## HISTORIC AND DESIGN REVIEW COMMISSION

February 15, 2017

**HDRC CASE NO:** 2017-058  
**ADDRESS:** 223 W HOLLYWOOD AVE  
**LEGAL DESCRIPTION:** NCB 6459 BLK 10 LOT 10, 11 & E 12.5 FT OF 9  
**ZONING:** R-5,H  
**CITY COUNCIL DIST.:** 1  
**DISTRICT:** Monte Vista Historic District  
**APPLICANT:** Bernice Beck  
**OWNER:** Bernice Beck  
**TYPE OF WORK:** Install door opening; window replacement  
**REQUEST:**

1. Replace all existing aluminum windows with new vinyl windows with false divided lights
2. Remove garage door and enclose opening
3. Install wood front pedestrian door in place of garage door

## Project No. 2, cont.

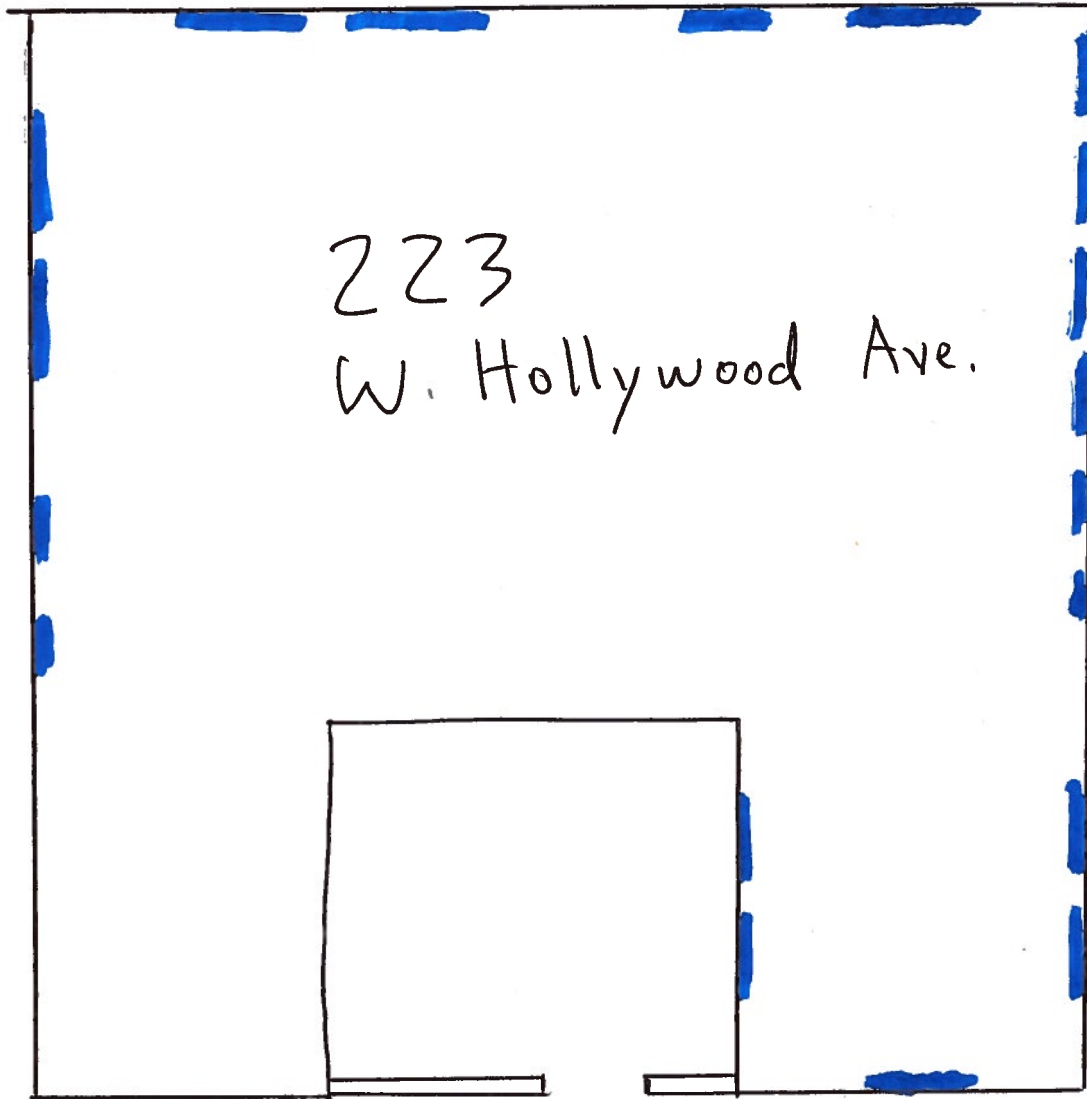
The wall is cracking in front. and will need support. We want to install a wooden entry door there to fix it. The door will look like other doors in neighborhood - Spanish style. My daughter will use that door when she moves in with me. The contractor said that we cannot put a window there because it would not provide enough support.

Proposed  
Door

- d. In place of a garage opening, the applicant is proposing a new, single-leaf wood door with a square window light, iron grate, and exposed metal bolts. In accordance with the guidelines, replacement doors should be characteristic of and compatible with the architecture style of the home. Staff finds the proposed door is compatible with the Spanish eclectic style. However, staff finds the proposal to replace a garage door with a single pedestrian door is not consistent with the Guidelines. A new fenestration pattern that maintains the original opening would be more consistent with the guidelines.

1. Staff recommends approval of window replacement based on findings a through b with the following stipulations:
  1. That the windows be replaced with wood window, with six-over-six, true divided lights and inset at least two inches and feature clear glass. A detail of the approved window must be provided to staff prior to issuance of a Certificate of Appropriateness.
2. Staff does not recommend approval of the installation of a single door where the garage door was removed based on finding c. Staff recommends the applicant explore options for a pedestrian door that fits the original garage door opening.
